SHOREHAM NUCLEAR POWER STATION

SNRC-924

Revised Responses to Acceptance
Review Requests 212.14, 212.76,
212.104, 223.38, 223.72 and 223.73
Final Safety Analysis Report (FSAR)
Shoreham Nuclear Power Station - Unit 1
Docket No. 50-322

FIG. 5.1.2-1B
 NUCLEAR BOILER SYSTEM P & ID
 SHOREHAM NUCLEAR POWER STATION-UNIT 1
 FINAL SAFETY ANALYSIS REPORT

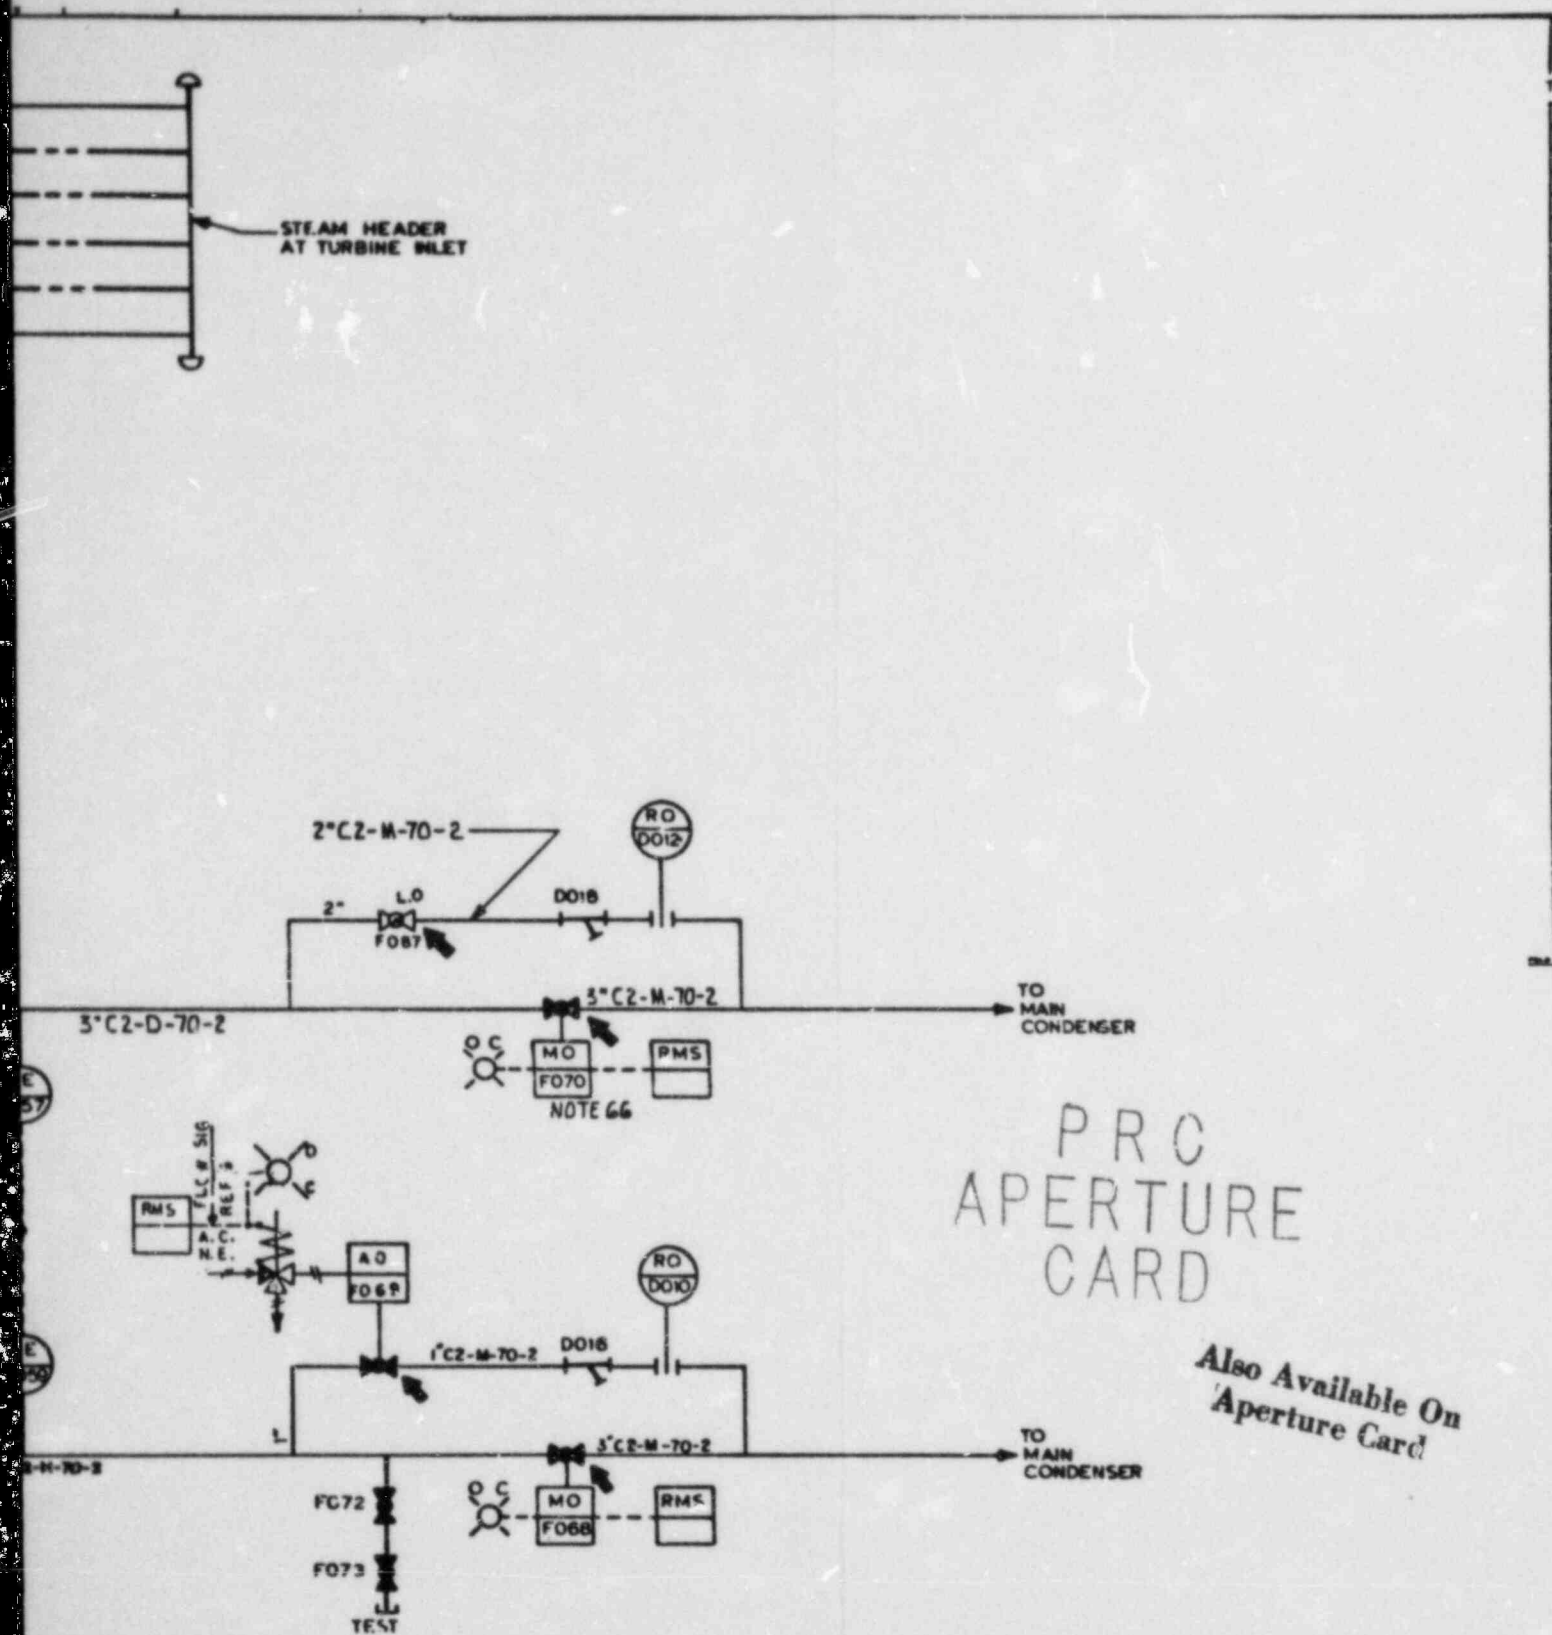
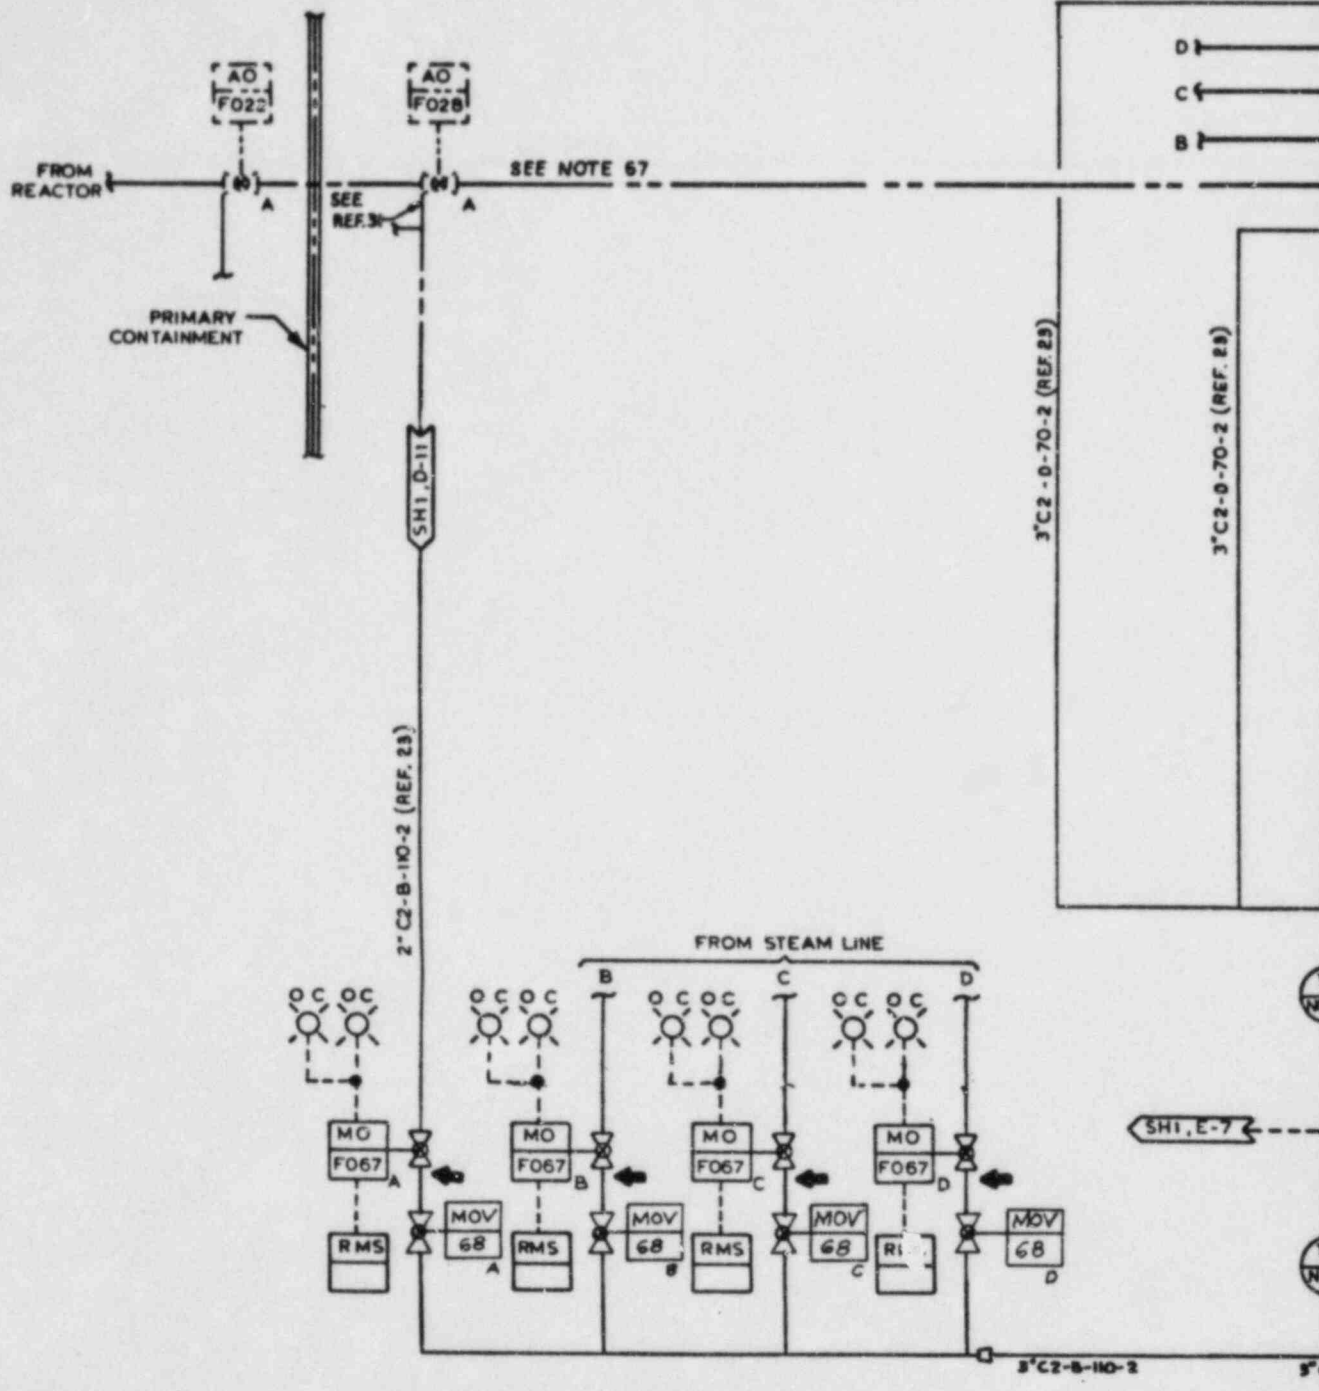
Several transient analyses in this section take credit for the recirculation pump trip (RPT) function. Description of these trip circuits is not presented in the FSAR. Discuss operation of this system as it was assumed to function to mitigate the transients analyzed in Section 15. Describe the signals or mechanisms that actuate the tripping devices and include setpoint values.

Supplement the description of the recirculation pump trip presented in Revision 5 to the FSAR with revised electrical schematics.

Figures 4.2.3-8A to -C, 5.1.2-1A to -C, 5.2.2-2A and -B, 7.7.1-1A to -C, 7.2.1-1A to -D, 7.3.1-7A to -E, 7.3.1-12A to -E, 7.7.1-2A to -G, and 7.7.1-5A to -E have been revised to include the RPT system.

FIGURE 15A.1.12-1
**POINT KINETICS CONTROL ROD
REACTIVITY INSERTION**
SHOREHAM NUCLEAR POWER STATION-UNIT 1
FINAL SAFETY ANALYSIS REPORT

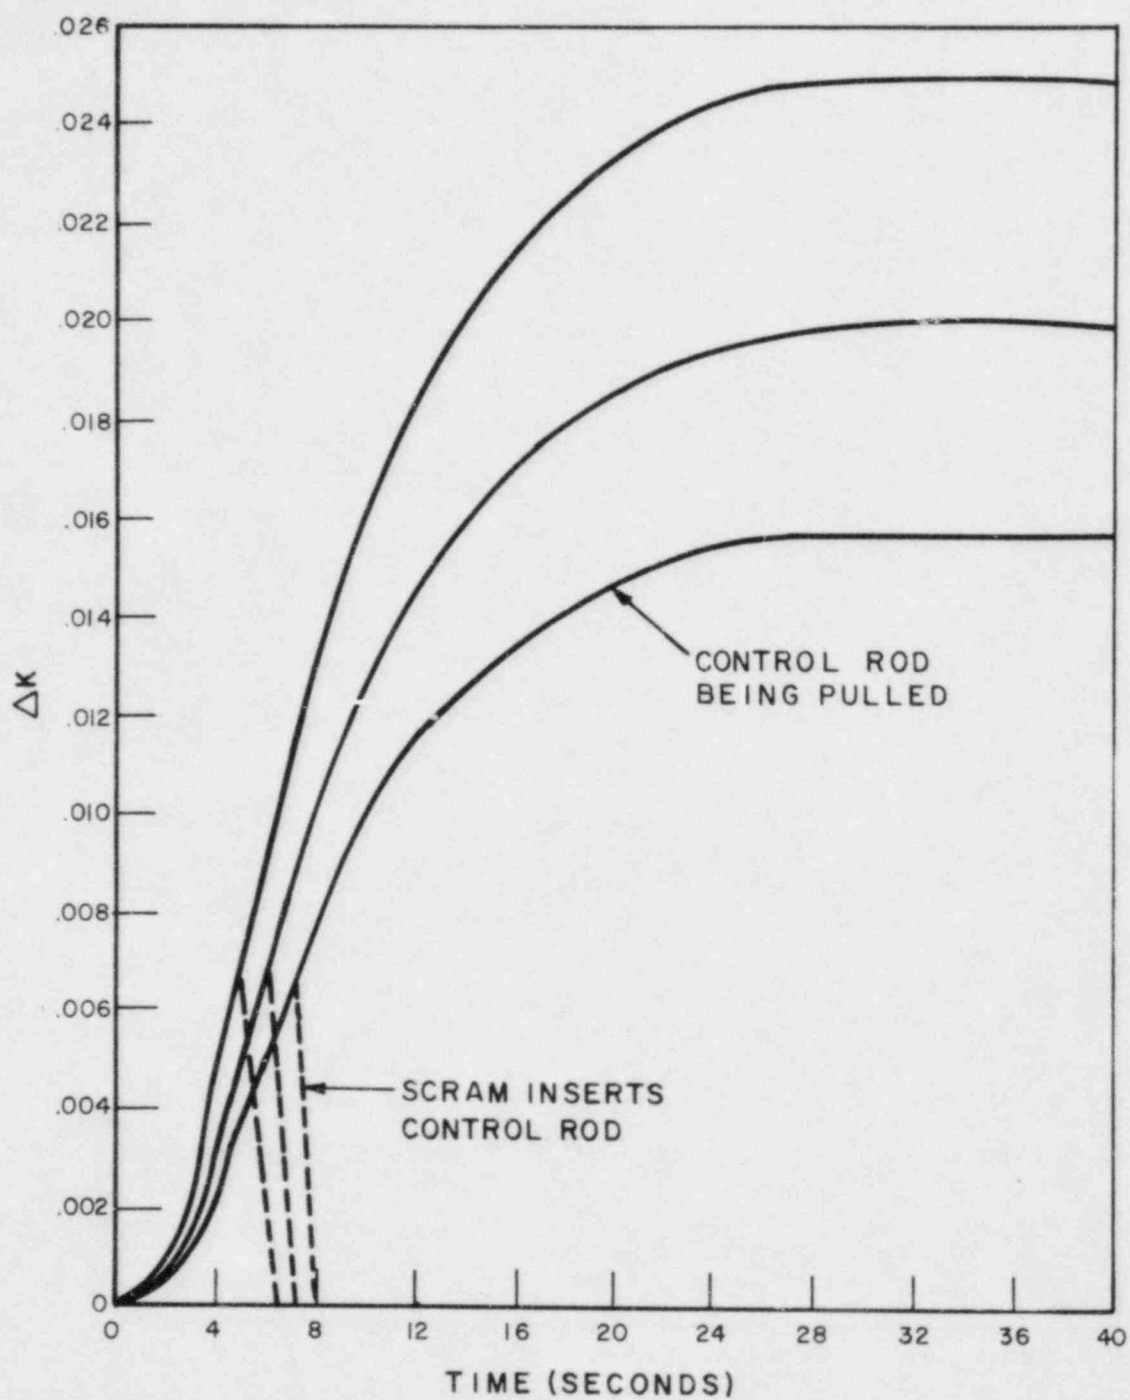
The Rod Sequence Control System is assumed to function in Section 15.0 of the FSAR to mitigate or prevent several accidents and as such it must be designed in accordance with criteria equivalent to that of protection systems. Provide the design basis description, drawings and all other information for this system.

An initial point kinetics calculation was run to determine the time to scram based on an APRM scram setpoint of 15 percent power and an initial power level of 1 percent. From this time and the maximum allowable rod withdrawal speed, it is possible to show the degree of rod withdrawal before reinsertion due to the scram. From this information Figure 15A.1.12-1 showing the modified effective reactivity shape, was constructed.
